DJR Operating, LLC requests permission to Plug & Abandon the subject well per the attached procedure, wellbore diagram, and reclamation plan.

Re: Permanent Abandonment
Well: DJR AXI Apache C11

API: 30-039-05146

CONDITIONS OF APPROVAL

AXI Apache C #11

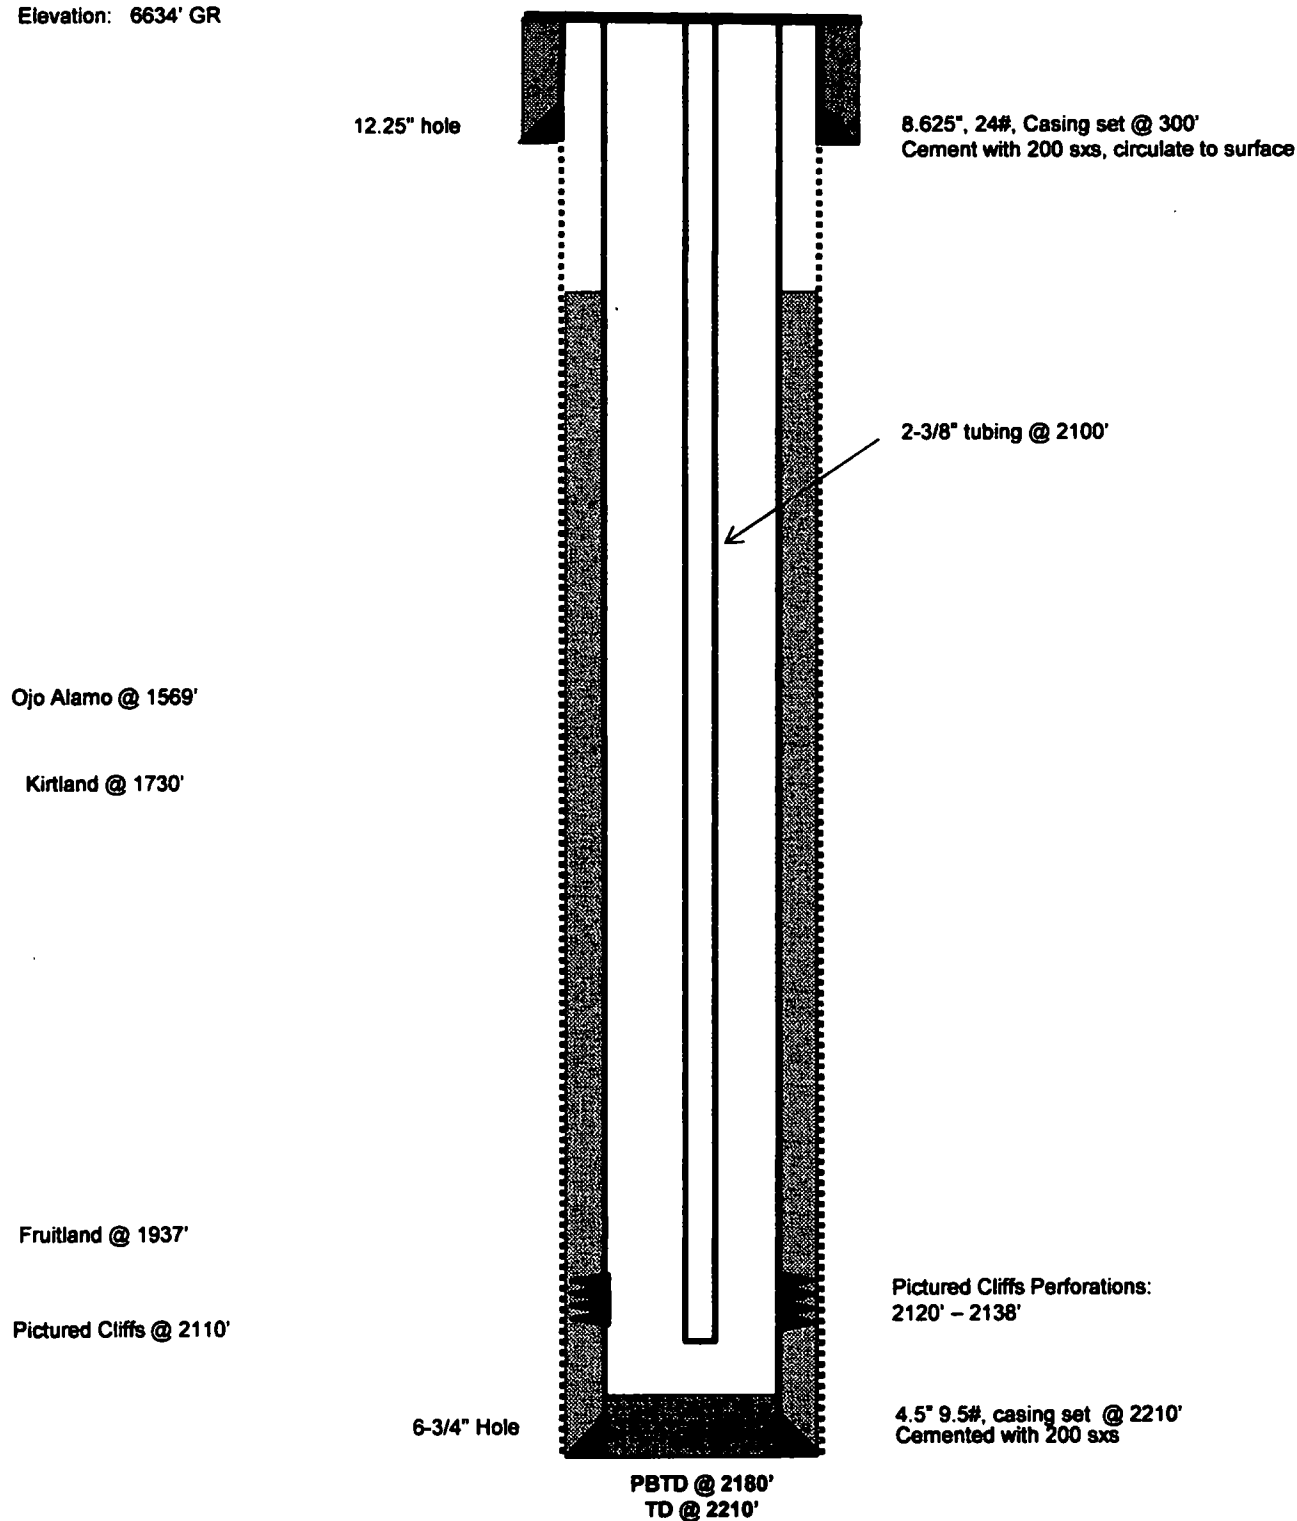
1. Plugging operations authorized are subject to the attached "General Requirements for Permanent Abandonment of Wells on Federal and Indian Lease."
2. Farmington Office is to be notified at least 24 hours before the plugging operations commence (505) 564-7750.
3. After setting CR, run a CBL from 2050 to surface. Submit electronic copy of the CBL for verification to the following addresses: jkillins@blm.gov , jhoffman@blm.gov and Brandon.Powell@state.nm.us . Based on CBL results inside/outside plugs and volumes will be adjusted accordingly. Please review the General Requirements document to ensure volumes meet required excess inside and outside casing.
4. BLM pick: top of Ojo Alamo is 1623 ft. Modify Plug #3 to cover 1673-1573 ft.

- BLM geologist's pick for the top of the Ojo Alamo and Kirtland formations vary from operators.
- Log analysis of reference well #2 (attached worksheet) indicates the Nacimiento and Ojo Alamo sands investigated contain fresh water ($\leq 5,000$ ppm TDS).
- Please ensure that the tops of the Pictured Cliffs, Fruitland, and Kirtland formations, as well as the entire Ojo Alamo fresh water aquifer identified in this report are isolated by proper placement of cement plugs. This will protect the fresh water sands in this well bore.
